**Coal Combustion Waste Impoundment
Round 5 - Dam Assessment Report**

Jefferies Generating Station (Site #002)

Santee Cooper
Moncks Corner, South Carolina

Dewberry & Davis, LLC
Fairfax, Virginia

EXHIBIT 1: REPRESENTATIVE SECTION OF PERIMETER EMBANKMENT

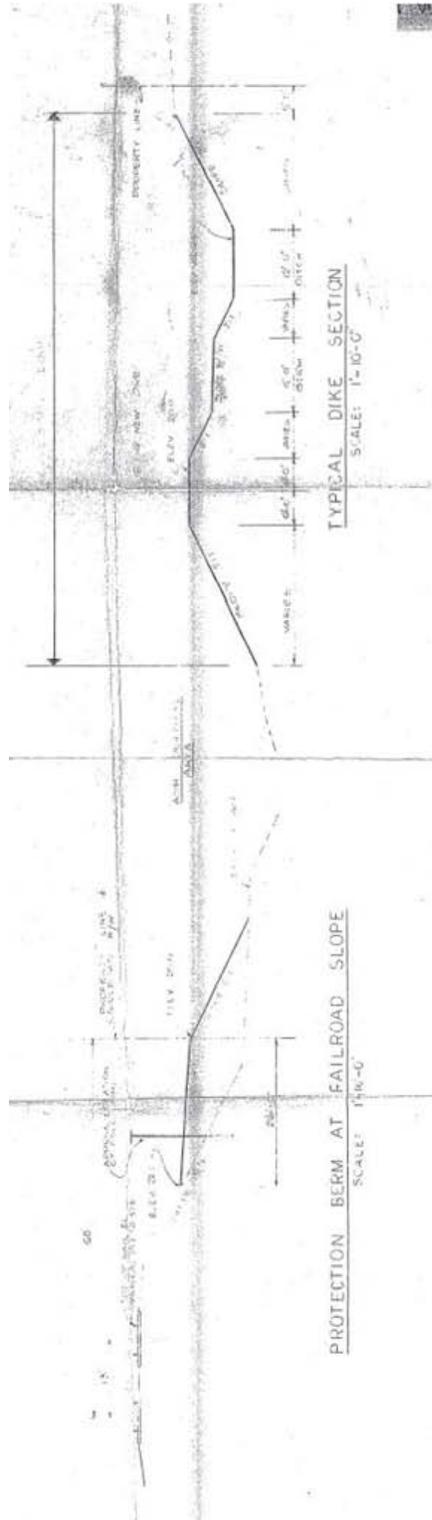
According to Santee Cooper, the geometry of the dam has not been altered since its original construction in 1970. Gravel surfacing was placed on the perimeter dam crest and on a perimeter road. A representative section of the perimeter embankment dam is shown in Exhibit 1. As shown in this exhibit, there is a 12-foot wide berm and 12-foot bottom width ditch along the toe of the outside slope. No internal drainage measures or toe drains were included in the embankment design for seepage control. The design of the perimeter dam embankment was basic and apparently consisted of one drawing as shown in (Appendix A – Doc 1.3). No geometric or other design information was provided for the cross dike embankment.
